Subject: Supplementary Site Characterization Report - Addendum

Subject: Supplementary Site Characterization – Addendum I
Sunny Piedmont Cleaners
Oakland, California

Please accept the attached revisions as Addendum I to the Supplementary Site Characterization Report dated August 6, 2010. The following revisions are included:

SITE PLAN
 Sunny Piedmont Cleaners
 Oakland, California

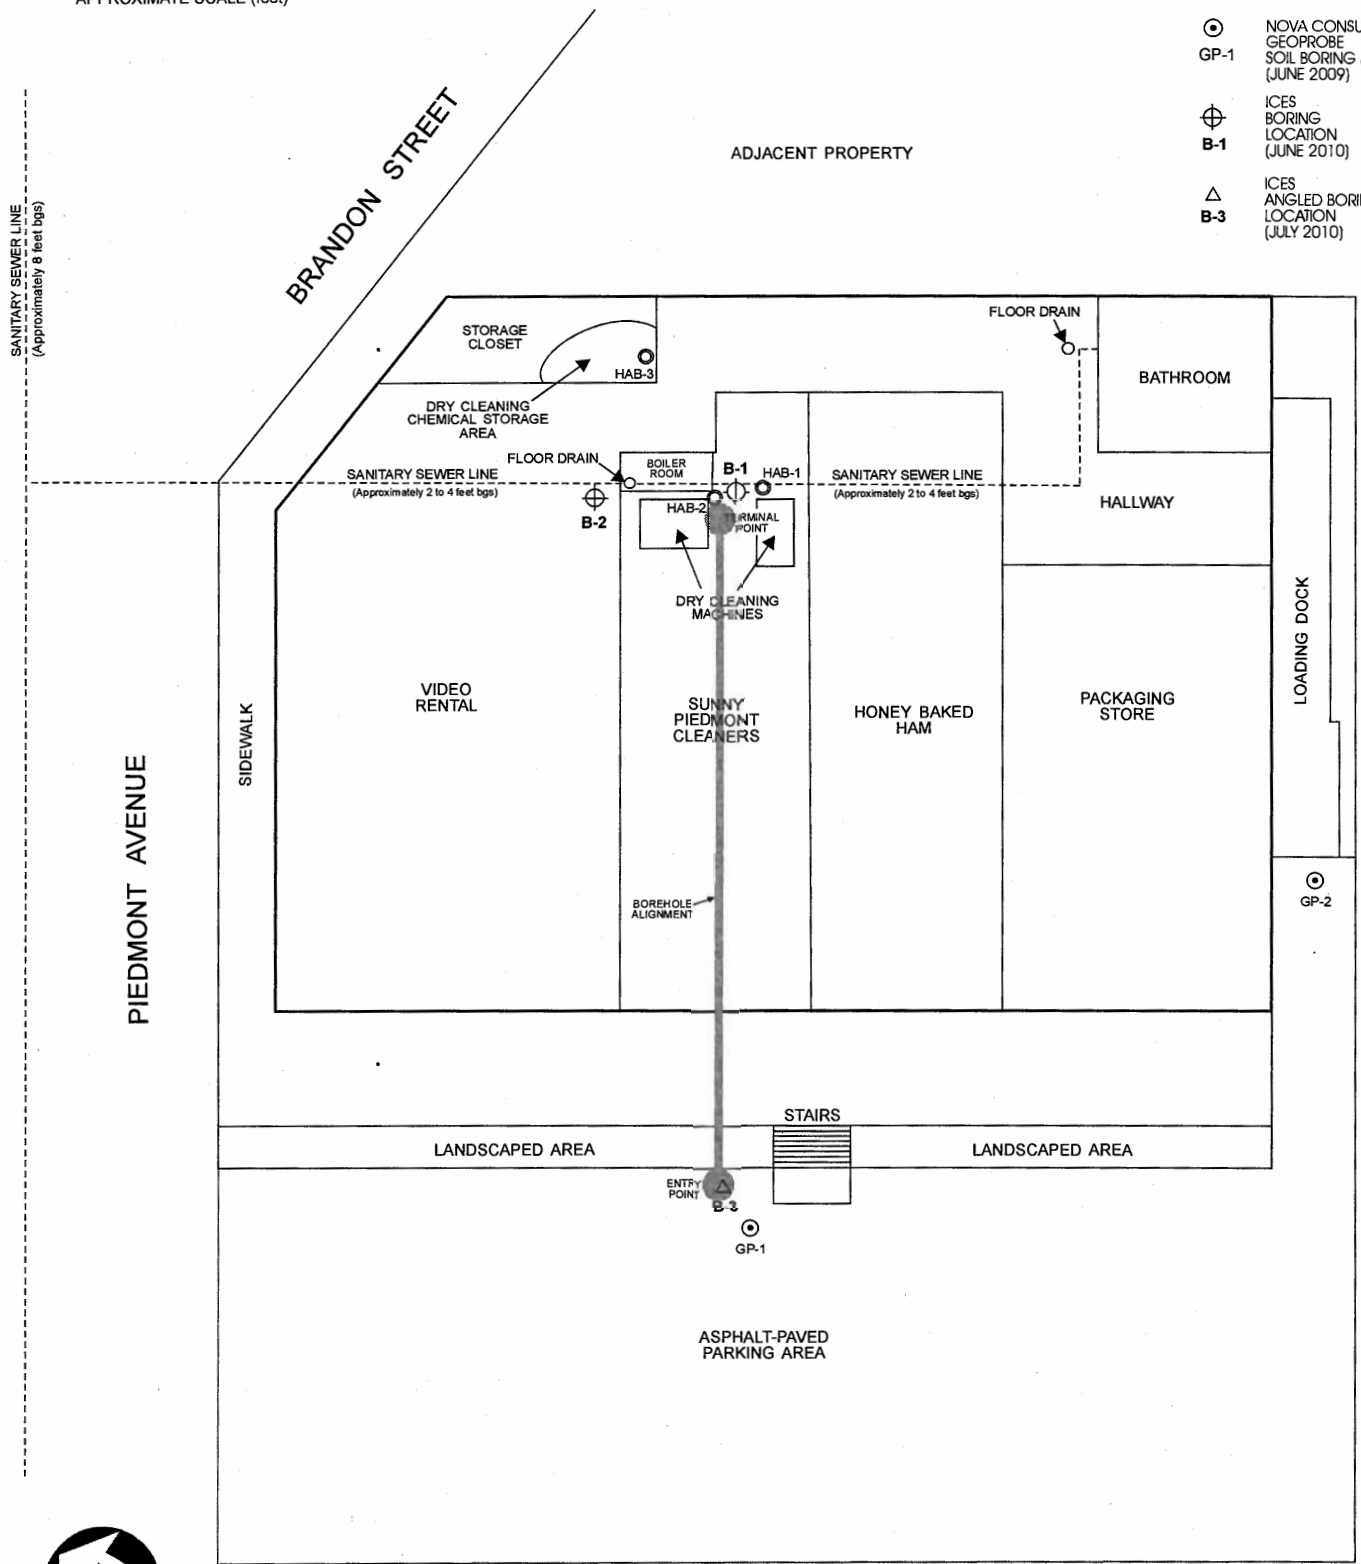
1. An angled boring was drilled using a sonic rig at boring B-3 to gain access to the groundwater beneath the dry cleaning machines within the building. Boring B-3 was located along the western perimeter of the building within the asphalt paved parking area, approximately 87 feet east of the dry cleaning machines (Figure 1).

BORING B-3 PROFILE

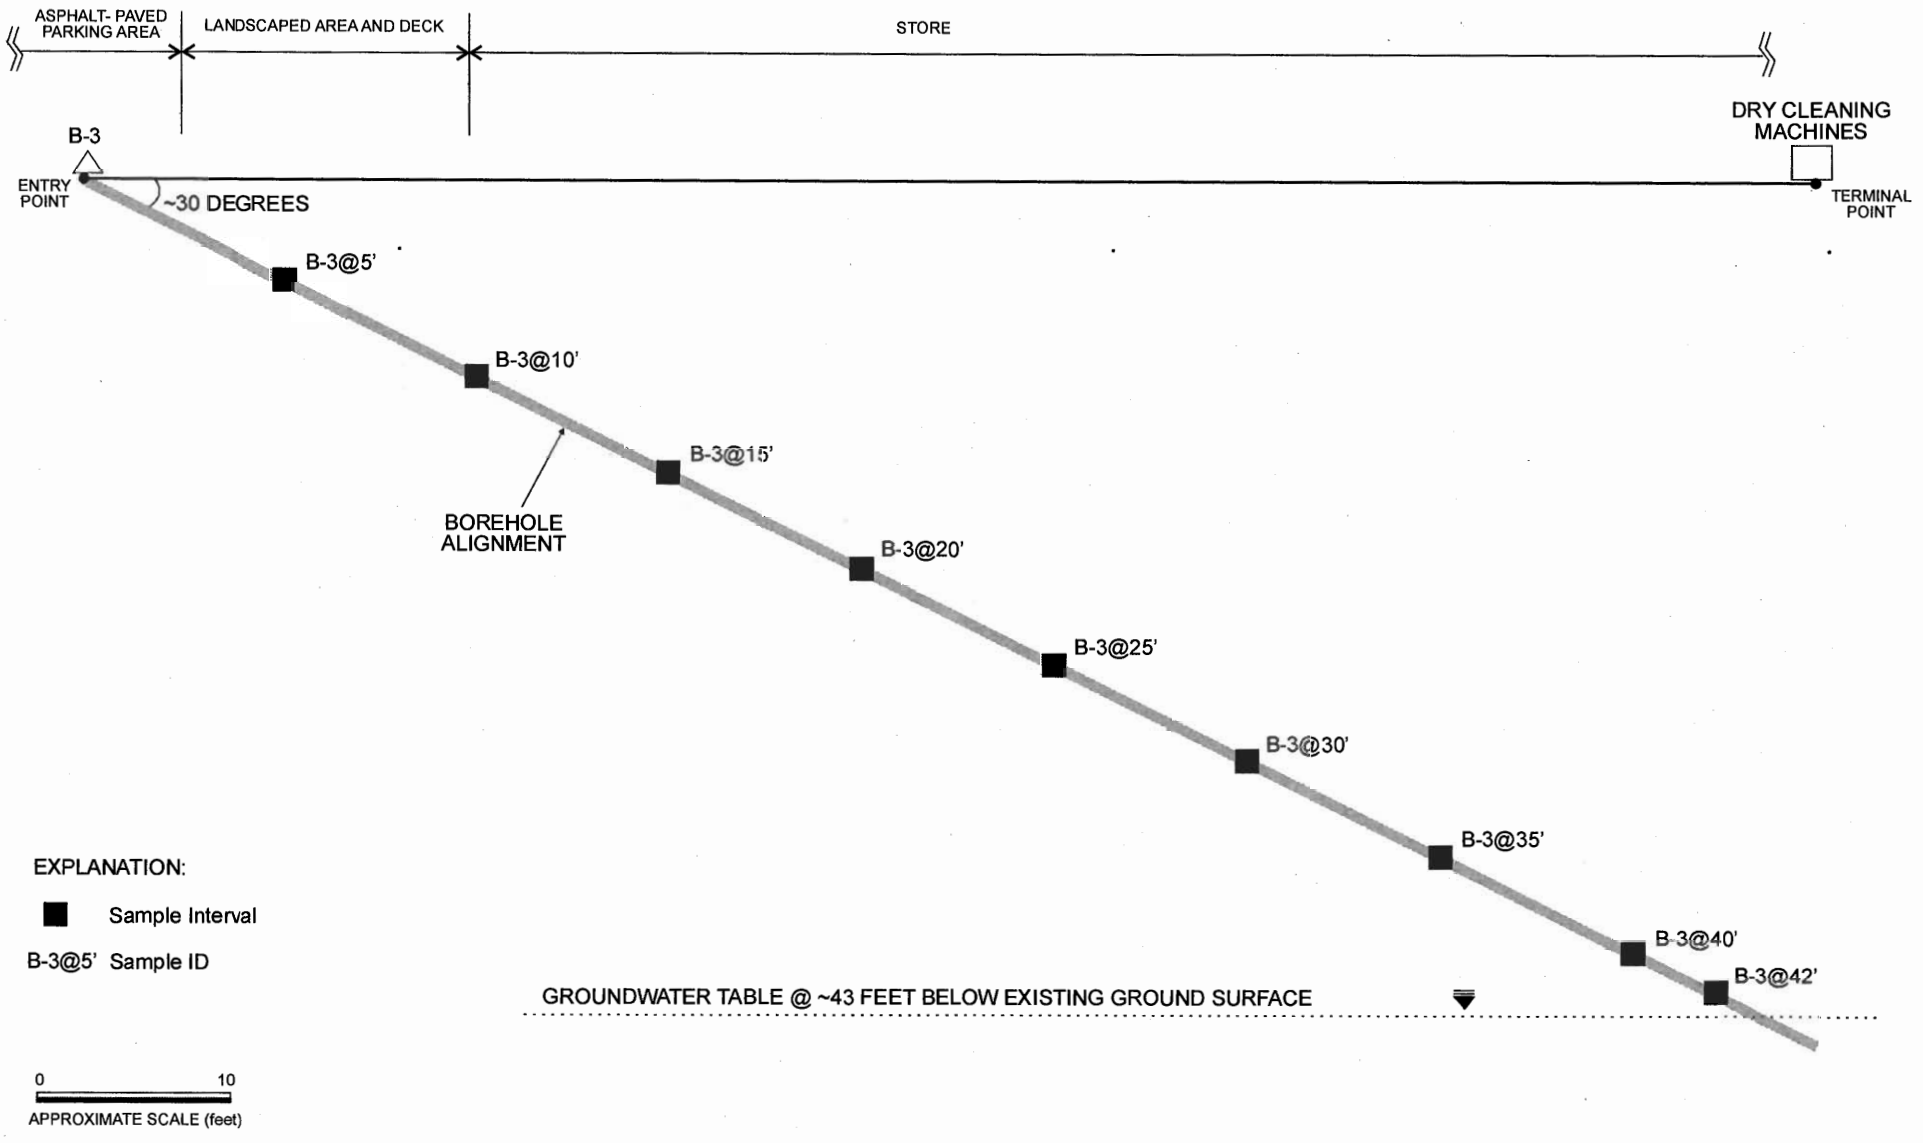
2. Starting within the asphalt paved parking area (located approximately 87 feet east of the dry cleaning machines; shown as "Entry Point" on Figure 2) and using an angle of approximately 30 degrees (measured relative to the horizontal plane of the asphalt paved parking area), approximately 98 feet of drilling rods were advanced along the boring alignment. The boring was terminated at a total length of approximately 98 feet (or the equivalent of approximately 45 feet below the dry cleaning machines; shown as "Terminal Point" on Figure 2).
